2CAN089302

Subject: Arkansas Nuclear One - Unit 2
Docket No. 50-368
License No. NPF-6
Information to Support Upcoming Steam Generator Meeting

On July 15, 1993, during Entergy Operation's meeting with the NRC to discuss eddy current methodologies utilized at Arkansas Nuclear One, Unit 2 (ANO-2), the Staff asked for certain information to be transmitted for their review. Entergy committed to provide this information to the Staff prior to ANO's August 30, 1993, steam generator (SG) meeting with the NRC. The items requested by the Staff are discussed below.

Figure 1. Free Body Schematic Load Diagram for Asymmetric Defect at Top of Tubesheet

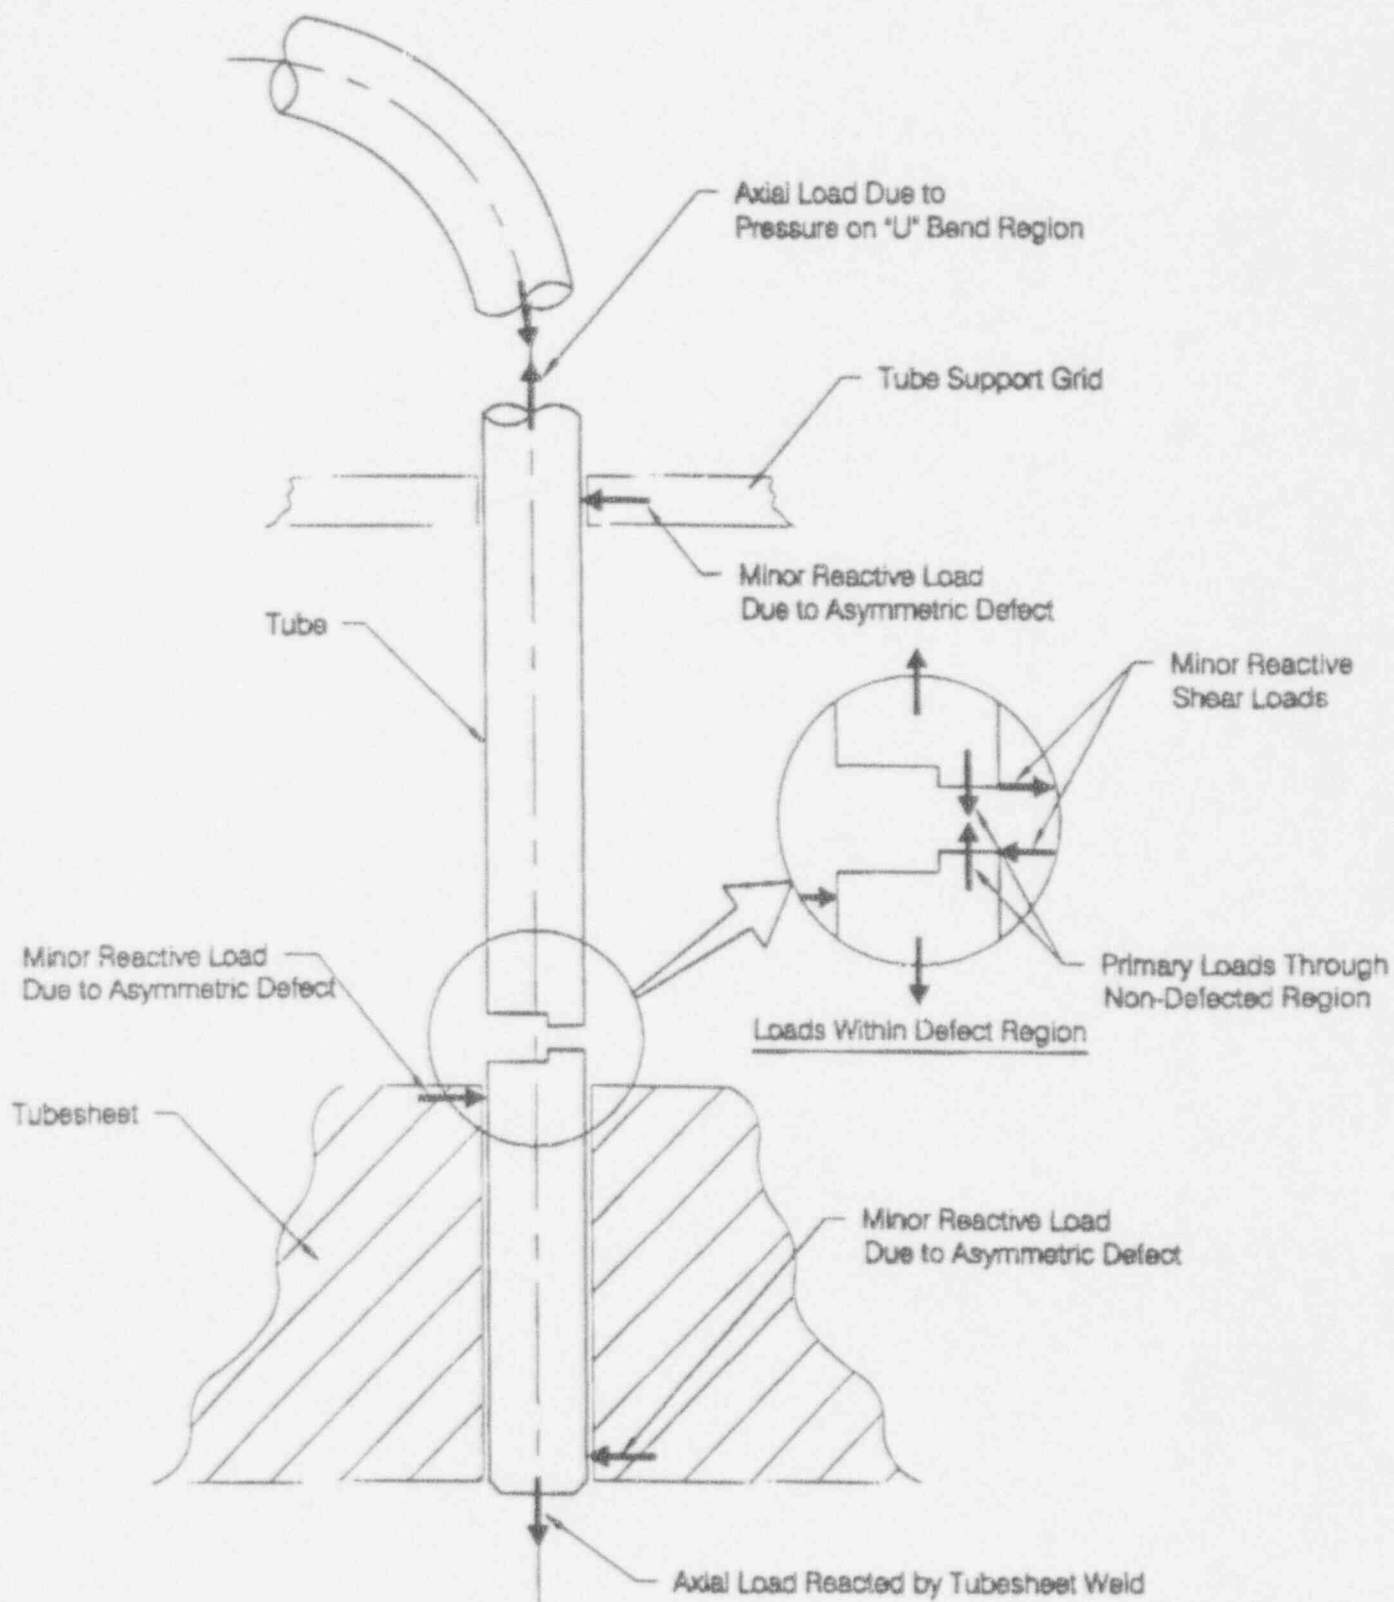
For circumferential cracks in vertical tubing the worst case tube load is in the axial direction, and is proportional to the average crack depth (total metal loss distributed uniformly over 360°) due to three times the operating pressure difference (per RG 1.121) applied within the "U" bend area (see Figure 1). Hoop stress within the defect area is not limiting and is lower than axial stress because the defect area is effectively bounded by a short axial length (0.25") planar defect (conservatively assuming no strengthening from ligaments between microcracks). This is further supported by data from NUREG/CR-0277 which indicate high burst pressures for short axial length simulated defects.

Post Burst Test Photographs of Steam Generator A Tube R64L48.

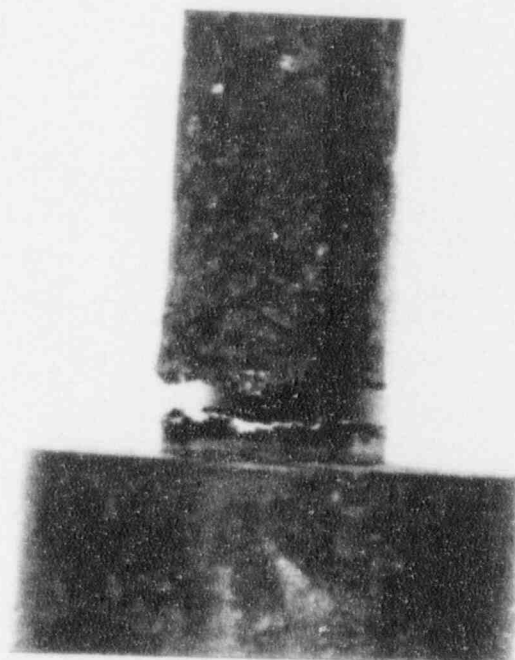
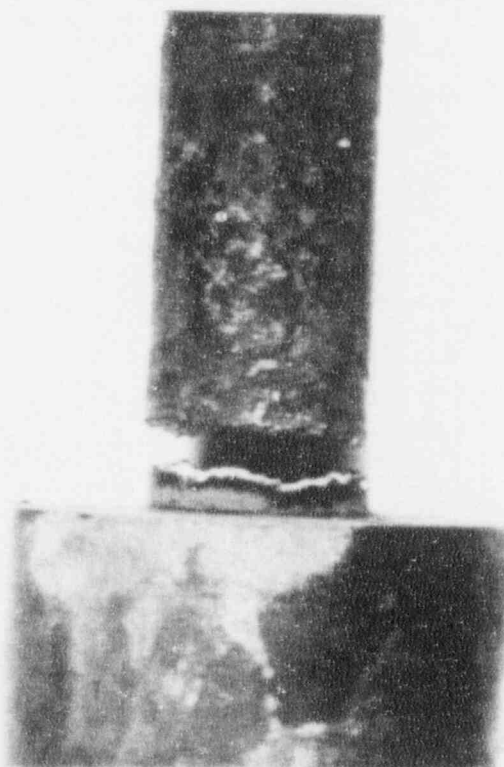
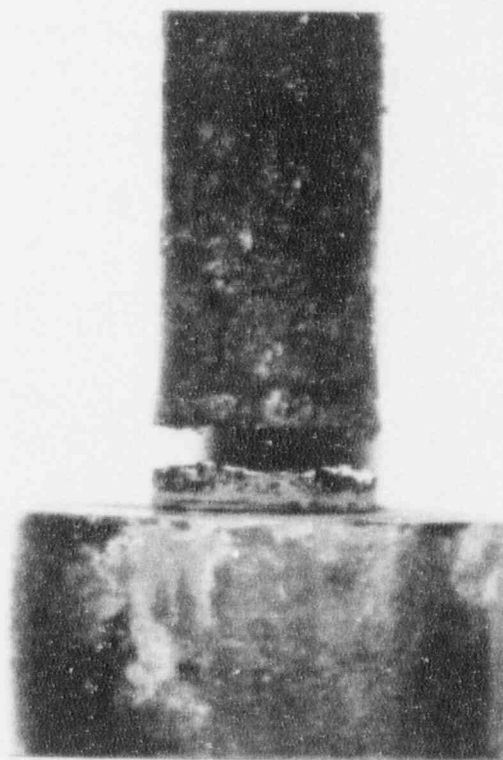
The limiting axial stress is inversely proportional to the non-defected cross section of the tube (within the defect area). Figure 2 illustrates the tube failure mode due to a burst test of a pulled ANO-2 tube (the tube is parted without bulging).

The ANO-2 burst test agrees with calculations based on average tube wall penetration as follows. Calculated burst pressure for a 72% throughwall (TW) average defect utilizing the same methodology as that to establish the 79% RG 1.121 limit for Tube 64-48, pulled during 2R9, is 5600 psi. The actual burst pressure was 5818 psi. The unaccounted for strength ($5818/5600 - 1 = 3.9\%$) is believed to be due to ligaments between microcracks. We believe that actual ligament strengthening is greater than that demonstrated by Tube 64-48, since this tube was damaged during removal. Also, an 0.25 inch axial extent was assumed for calculation of the allowable circumferential crack. This would be the same as a groove 0.25" wide all the way around the circumference. Since the ANO-2 cracks are tight cracks, this is conservatively simulating the flaws and provides additional margin for safety. The RG 1.121 calculation is included as Attachment 1.

FIGURE 3

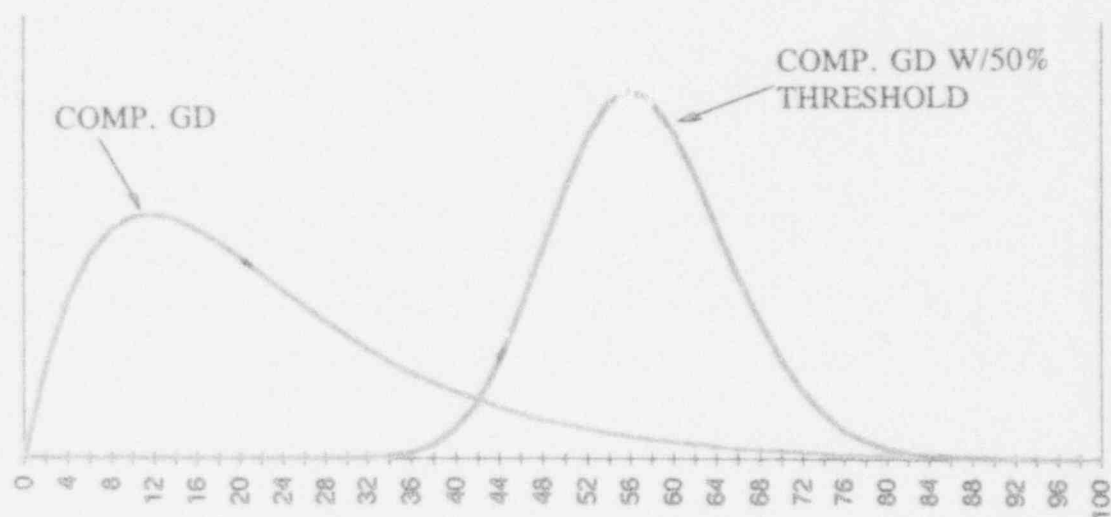
5. Response to Question on the Use of MRPC to Determine the Average %TW and the Request to Use a 50% TW Threshold for the Portion of the Crack not Seen by MRPC.

Figure 3 shows the change to the distribution curves resulting from assuming a 50% TW threshold for the portion of assumed cracks not seen by MRPC. Using the 50% threshold drastically shifts the curve right, but also changes its shape such that it forms a normal distribution curve. We do not believe that SCC behaves in this manner, but rather that there are many more small cracks than large ones, giving a distribution that is not uniform and normal. Utilizing the 50% threshold does, however, cause one cracked tube to be calculated as $\geq 79\%$ TW that wasn't in our original calculation, and thus causes the probability of not having a crack in excess of RG 1.121 limits to decrease from 97.4% to 96.8%.
